E8257N-01

Modification Recommended Service Note

E8257N Sweep Generator

Figure 1 (* using E8257D screen short as an example)

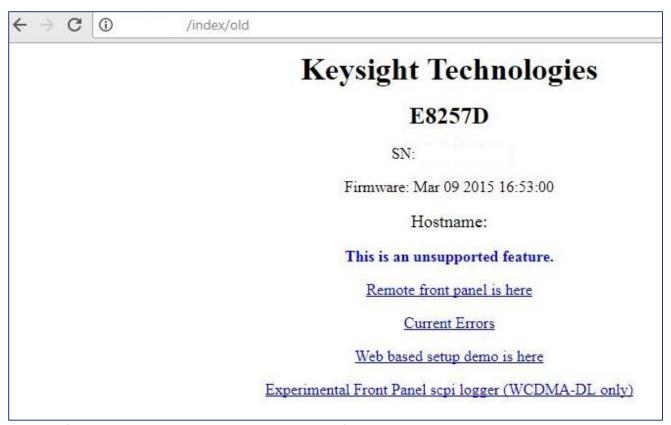
Instrument when access via internet browser by entering the IP address (http:<instrument IP address>) will get http:<instrument IP address>/index/old page as shown below instead of http:<instrument IP address>/default.html page.

This problem can be resolve by upgrading the instrument with the current firmware using the Firmware Upgrade Assistant from the Signal Generator Firmware Update Center,
